REGIONAL REVIEW NOTICE

ARC REVIEW CODE: R1403071

Name of Proposal: 98 14th Street **Review Type:** DRI **Submitting Local Government:** City of Atlanta
Date Opened: March 7, 2014 **Deadline for Comments:** March 22, 2014 **Date to Close:** March 22, 2014

SUBJECT: **Transportation Division Review of DRI # 2390**

SITE PLAN

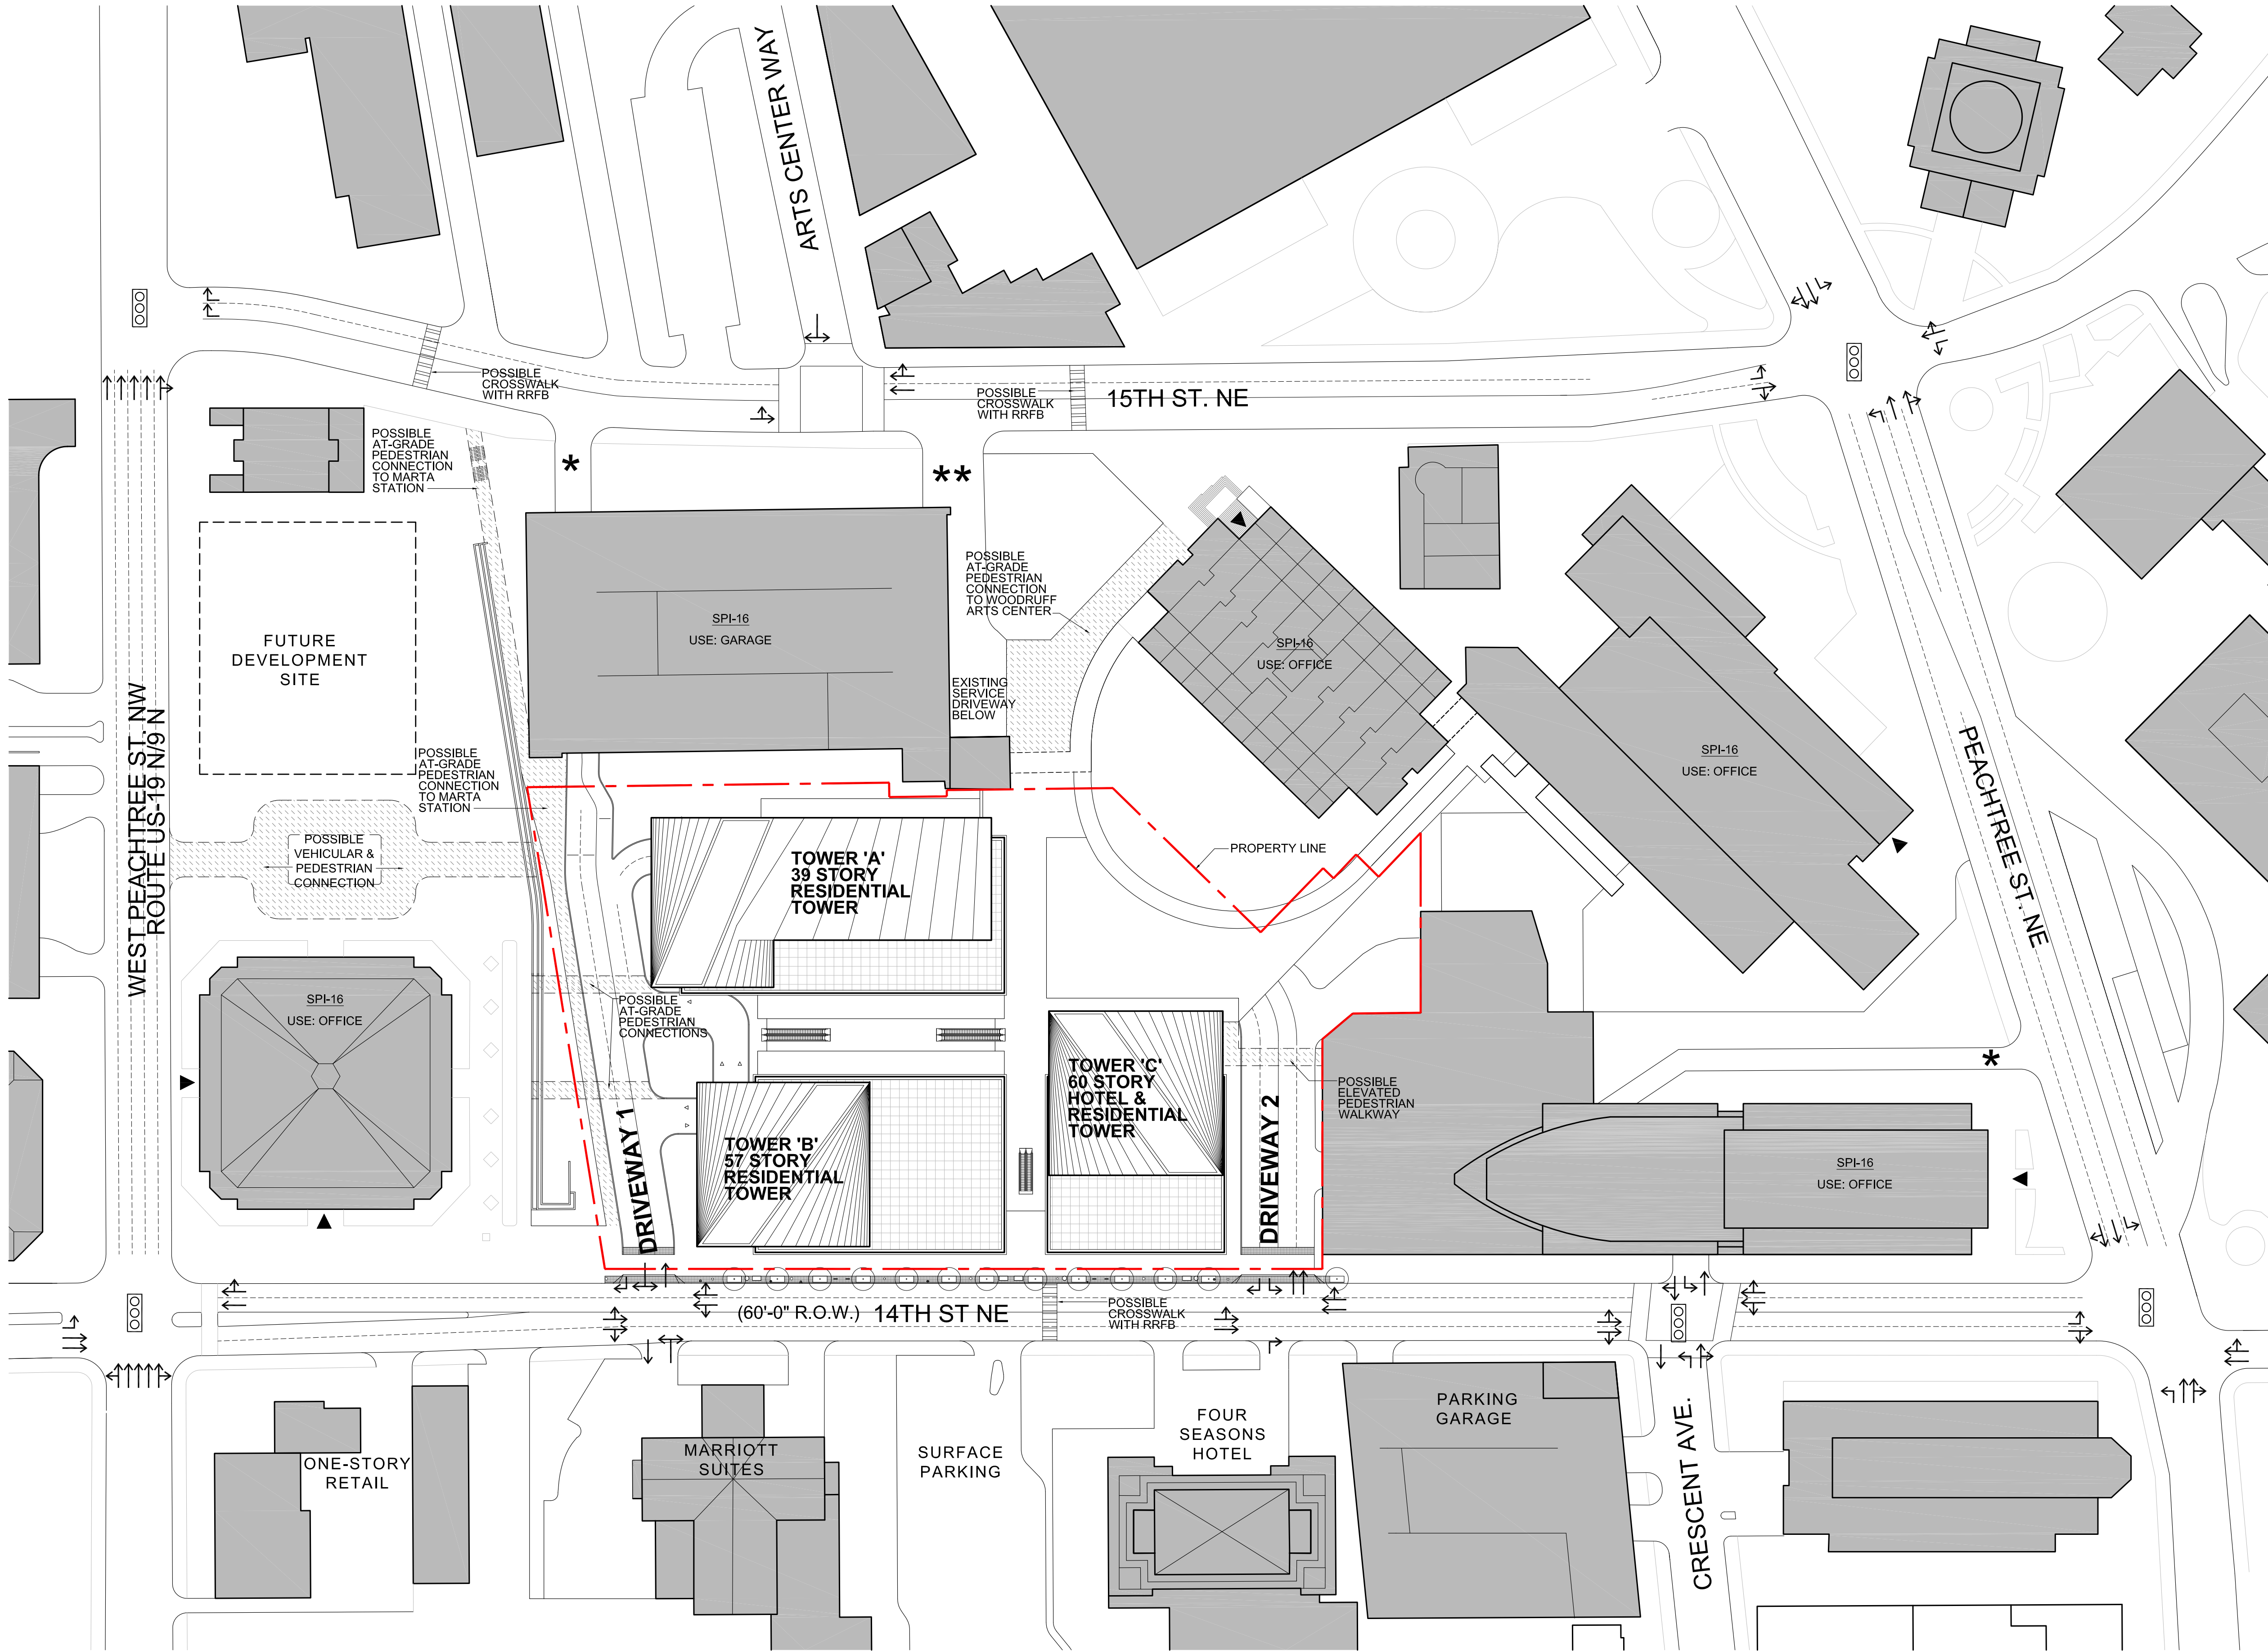
Site access is proposed via two locations, both of which are existing driveways on the north side of 14th Street. Both of these existing drives serve other developments. Driveway #1 is located on the eastern edge of the site, 365 feet east of West Peachtree Street. Driveway #2 is located on the western edge of the site, 620 feet from Peachtree Street and approximately 220 feet from the nearest signalized intersection (Crescent Street & 14th Street) which serves as another access point for Symphony Tower. Residential and retail traffic will use both of these drives, while hotel traffic will primarily use Driveway #2. An existing service driveway along 15th street will serve as a shared service vehicle only driveway and will primarily be used during off-peak hours. A City of Atlanta representative requested that there be no 4-lane driveways in order to promote safety for pedestrians using sidewalks that cross these driveways..

Due to the considerable congestion that is currently present on 14th Street, alternative access points should be considered to the following two locations:

- Options should be explored to connect the subject site parking facility to 15th street. This could be accomplished by connecting through the Promenade parking deck that abuts the northern edge of the subject site, and which currently has access to both 14th Street and 15th Street. In this configuration, opportunities for shared parking could be explored with the Promenade parking facility. 15th Street experiences much lower congestion levels than 14th Street and is a potentially viable location to route vehicles exiting the subject site.

- The applicant expressed an interest in connecting to West Peachtree Street, with a “drop-off area” serving One Atlantic Center. This drive would connect one subterranean level of the subject site parking facility with West Peachtree Street. A driveway such as this could benefit the patrons of One Atlantic Center by providing a protected off-street drop-off area. This access point may provide considerable congestion relief on 14th Street from the added trips generated by the applicant's site due to the fact that a large contributor to queuing along 14th Street is the right-turn movements onto West Peachtree Street.

- A crosswalk, potentially with rapid flashing beacons, should connect to the subject site across 14th Street.
- The development should include multiple connections to walkways on neighboring properties in order to enhance access to the Arts Center MARTA Station.
- The applicant expressed interest in creating a path over the MARTA rail vault on the western edge of the property that would connect to 15th Street and this is highly encouraged.
- The developer should coordinate with the City of Atlanta to explore opportunities with the upcoming bike-share system.
